MFN 06-097

**Subject: Partial Response to NRC Request for Additional Information Letter
No. 6 Related to ESBWR Design Certification Application –
Instrumentation and Control Systems – RAI Numbers 7.1-1 through
7.1-5 and 7.4-1**

GE Response to Request for Additional Information
Letter No. 6 Related to ESBWR Design Certification
Application – Instrumentation and Control Systems
RAI Numbers 7.1-1 through 7.1-5 and 7.4-1

Figure ZZ
ESBWR DCIS Remote Shutdown Panels

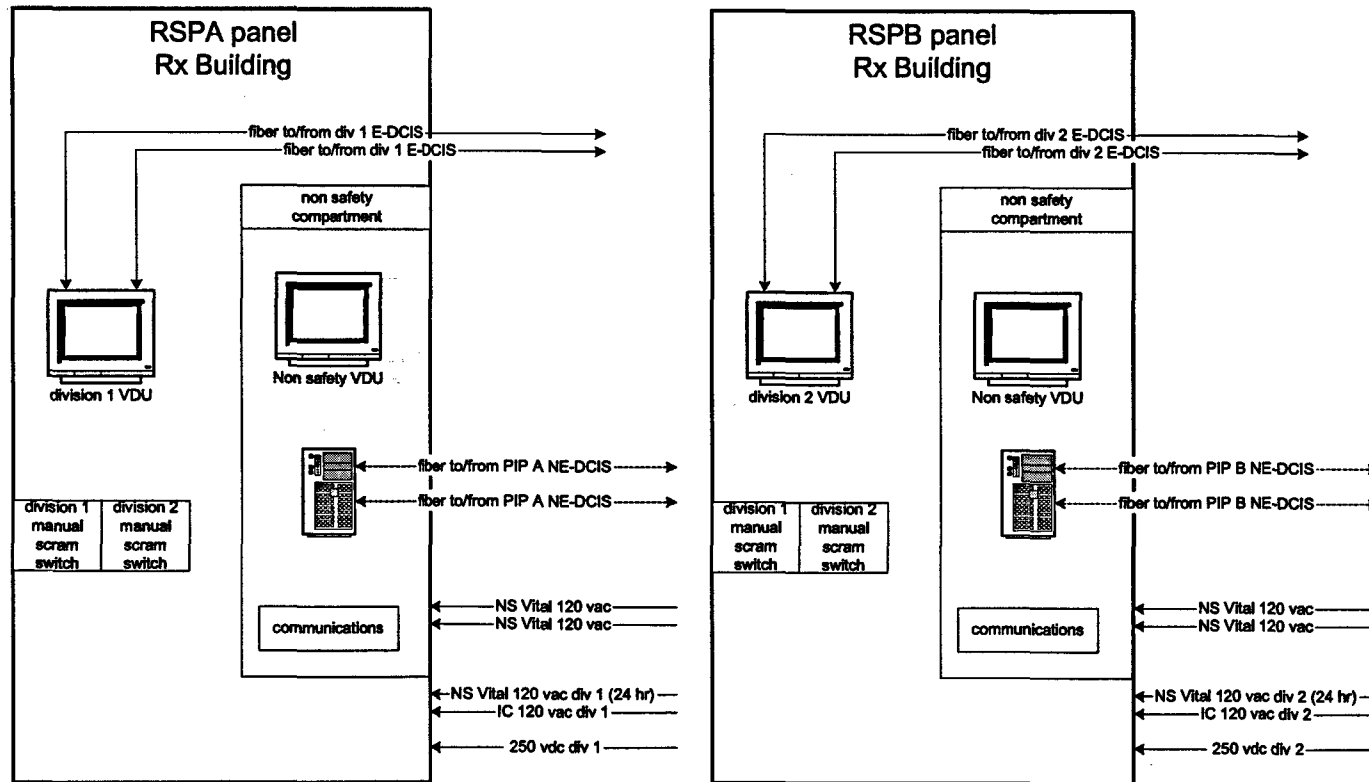
NRC RAI 7.4-1

Provide remote shutdown system (RSS) visual display unit (VDU) control capabilities and demonstrate separation/ isolation between safety and nonsafety.

The DCD states that the remote shutdown system (RSS) has two redundant and independent panels, each contain a safety related digital visual display unit (VDU), and a nonsafety related VDU. From these VDUs it is possible to control both safety-related and nonsafety-related systems. Please provide detailed information of RSS control capabilities and provide drawings to demonstrate the separation/isolation between safety and nonsafety systems. Also provide the design basis to qualify the VDU for safety related application.

The remote shutdown system (RSS) described in DCD Tier 2, Section 7.4.2 consists of two panels (reference figure ZZ) located in the reactor building. Separation and isolation is preserved both mechanically and electrically in accordance with IEEE 279 and RG 1.75. Each of the two panels is compartmentalized (similar to the main control room benchboards) into a safety related and non-safety related section; the safety related section in one of the panels contains a division 1 safety related Visual Display Unit (VDU) and the other panel contains a division 2 safety related VDU. The safety related VDUs are part of the appropriate divisional Essential Distributed Control and Information System (E-DCIS) and connected to the DCIS via fiber optics to the appropriate divisional safety related DCIS in the division 1 (2) DCIS room. The panels are located in the quadrant of the reactor building corresponding to the division of the safety related VDU.

As shown on Figure DCD Tier 2, Figure 7.4.1 and the attached figure ZZ, the nonsafety-related section in each of the two RSS panels contains a non-safety related VDU; the VDU is part of the non-safety Non-Essential DCIS. The RSS panel containing the division 1 VDU houses a non-safety VDU in the non-safety compartment of the Plant Investment Protection (PIP) segment of the non-safety DCIS and the RSS panel containing the division 2 VDU houses a non-safety VDU in the non-safety compartment of the PIP equipment segment of the non-safety DCIS. The non-safety VDUs are connected to the PIP segment in the non-safety DCIS room A (B) via fiber optics.

The main control room environment/HVAC/fire zone is separate from the safety and non-safety DCIS rooms and the connections to the control room VDUs are also via fiber optics. The design bases described in DCD Tier 2, Subsection 7.4.2.1 is such that the main control room can be lost to fire or evacuated without affecting the continuing automatic or manual operation of the safety and non-safety DCIS. As a result all of the safety and non-safety capability of the control room VDUs is duplicated at the RSS VDUs. Specifically if offsite power is available the non-safety displays enable the operator to perform a controlled shutdown using normal heat sinks.

If offsite power is lost but the diesel generators have started, the non-safety displays can control PIP equipment such that the operator can perform (for example) a controlled shutdown using Reactor Water Cleanup/Shutdown Cooling via Reactor Coolant System and Plant Service Water System.

If all non-safety power is lost, the operator can control everything in division 1 (2) including the isolation condensers, Automatic Depressurization System, Gravity-Driven Cooling System, the equalizing valves and the deluge valves; automatic or manual actions in these systems can shut down the reactor and leave it in a safe state. In all cases the operator will control and monitor the various systems in the same way it would normally be done in the control room and no interlocks are lost requiring special manipulation.

DCD Tier 2, Subsection 7.4.2.2 specifies that if all non-safety power is lost, than the operator can monitor non-safety information from the RSS for the two-hour battery capacity of the non-safety vital AC system. The safety related section of each RSS panel is powered for 72 hours, as is all other safety related division 1 and 2 monitoring equipment. Should the diesels start or offsite power become available, the RSS panels will be powered indefinitely.

DCD Tier 2, Subsection 7.4.2.2 discusses that access to both the reactor building and specifically to the RSS rooms is controlled and the doors to the RSS rooms are alarmed in the main control room. The VDUs are part of the safety and non-safety DCIS self-diagnostics as discussed in DCD Tier 2, subsection 7.9.2.2.

Each RSS panel has a division 1 and 2 hard wired manual scram switch, DCD Tier 2, Subsection 7.4.2.2, which may be used to scram the reactor from the RSS whatever the

state of the MCR. The switches are appropriately compartmentalized and the wiring is fail-safe.
